KONE TYPE ADV AND ADT DOORS WITH CURTAIN OF LIGHT SAFETY EDGE

KONE LIFTS LTD	Subject				CODE: SN 03.17.01
	<u>ADV & ADT + CURTAIN OF LIGHT SAFETY RISK.</u>				Pages: Total 6 SAFETY CATEGORY A
DEPT. TECH.SUPP	DATE 3.6.98	COMPILED BY A J Shiner	CHECKED V J Kaura	APPROVED <i>ASh</i>	ISSUE B

ADV & ADT + CURTAIN OF LIGHT SAFETY RISKSN 3.17.01
Page 2 of 6
Safety Category A
ISSUE B.**1. Products affected**

Figure 1. Unintentional opening of the landing door

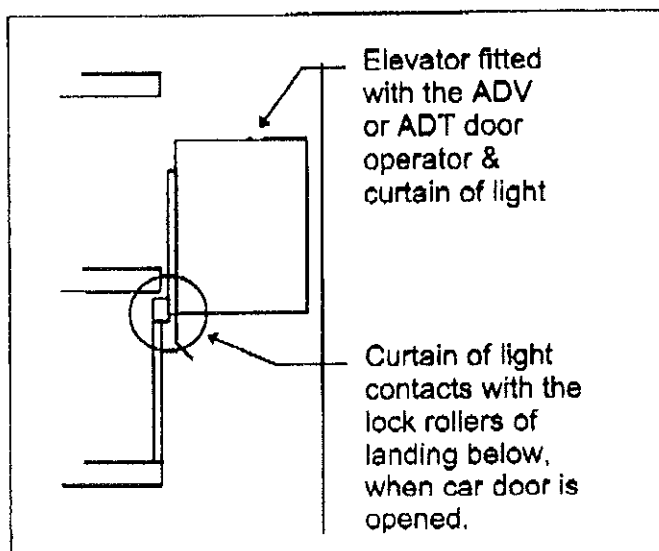
The COL safety edge has a theoretical 1mm gap between it and the landing door rollers, in many inspected elevators this gap does not exist. It is then possible that during maintenance or emergency evacuation, when the elevator car is positioned 1 meter or more under the landing level, the opening of the car door can also open the landing doors of the floor below. This exposes the empty shaft to users. Children are especially at risk in these situations.

The opening of the car doors when the car is below the normal level **cannot occur during the normal operation of the elevator**. The only possibilities for the car to be out of level and the car doors opening are when there is a maintenance visit, or a callout to a trapped passenger or stuck elevator.

The opening of the landing door below exposes a real possibility of a member of the public falling into the pit. In the past 5 years there have been four reported cases (not with the ADV or ADT) when a user has walked into a darkened shaft without the elevator being at the level, three of these have been fatal.

Figure 2. Clearance between curtain of light and landing door rollers

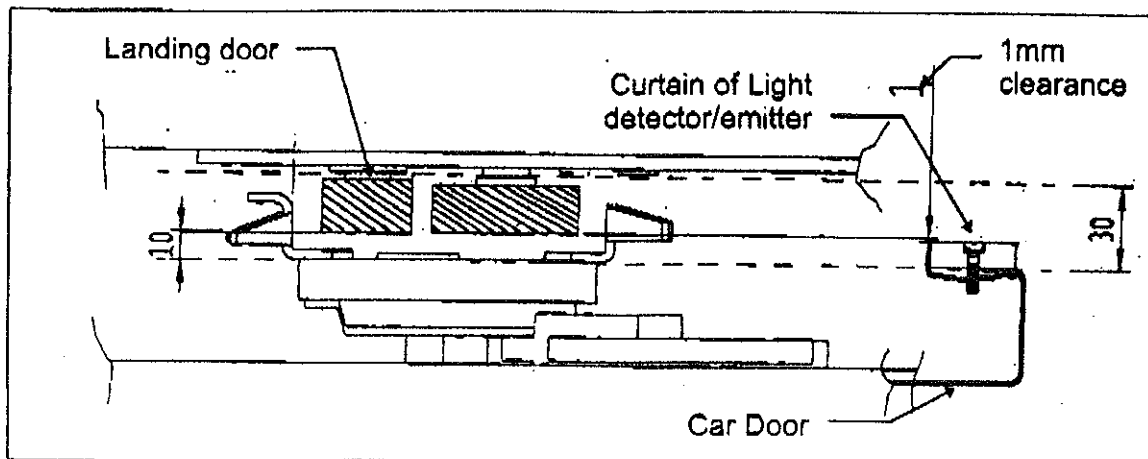
The clearance between the curtain of light emitter/detector unit and the landing door rollers is 1mm, and during installation, maintenance or natural wear and tear this clearance can be removed and lead to the safety risk.

The corrective actions for this case are in two steps, first a temporary fix and then the hazard elimination. In both cases the actions can be taken during the regular maintenance of the elevators.

All callout and maintenance employees must be made aware of this safety risk, and as part of the regular maintenance the clearance gap must be checked and maintained.

An employee can quickly check by carefully opening the car door by hand and seeing if the landing door rollers are hit by the curtain of light at each landing.

Figure 3. Warning sign for the car door header

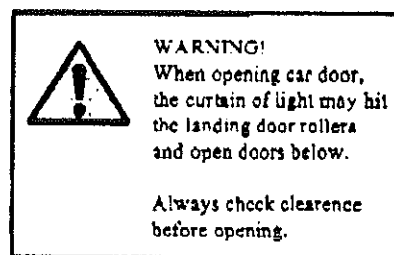
It is recommended that a warning sign is produced locally, and stuck next to the car door maintenance test buttons. An example of a sign and text are shown below in Figure 3. The placing of the sign can be seen in Figure 4.

Figure 4. Fixing of curtain of light to the car doors and to the car sill

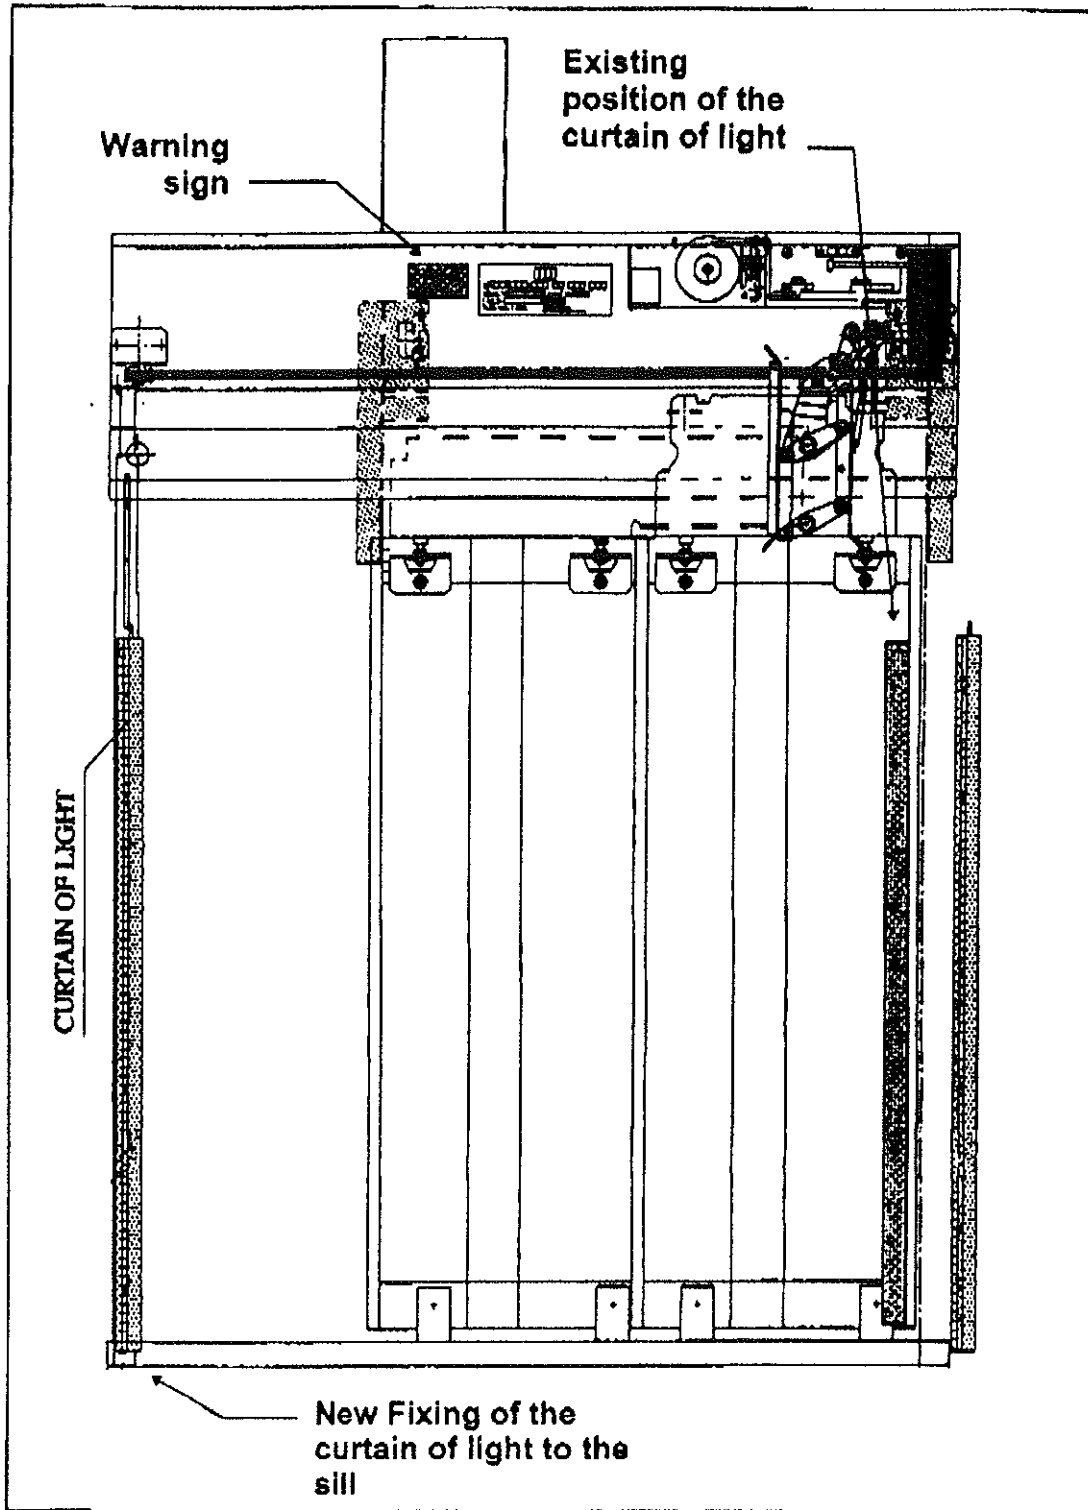
The position of the COL safety edge will be moved from the door leading edge to a fixing on the sill as seen in figure 4 below. The modification kit is available from the Pero factory and can be ordered using the form in Appendix 1.

The curtains of light will always be provided with fixings to the end of the car sills for all new deliveries.
